URGENT: Field Safety Notice

Jasper™ HPLC System

SCIEX is initiating a field action for the product listed above.

Photo 1:
Damaged Board/Cables

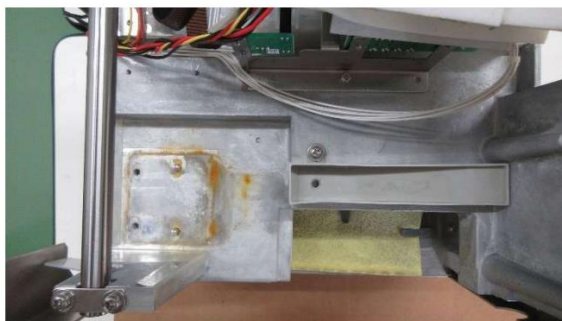
In rare occasions, in JasperLC autosamplers with the temperature control function, there have been cases where the main board and adjacent cables were partly charred. The cause is that condensation water drained from Peltier dehumidifier, leaked out from the tray, resulting in short circuit. Even in the case that there is no such damage, the Y motor and its surrounding die cast part may become rusty.

SCIEX will arrange to inspect the JasperLC autosampler for leakage. Depending upon the findings, the SCIEX engineer will install a Main PCB protective sponge and a dew tray replacement kit, if necessary. If any problems are found with internal components of the autosampler related to leakage they will be replaced.
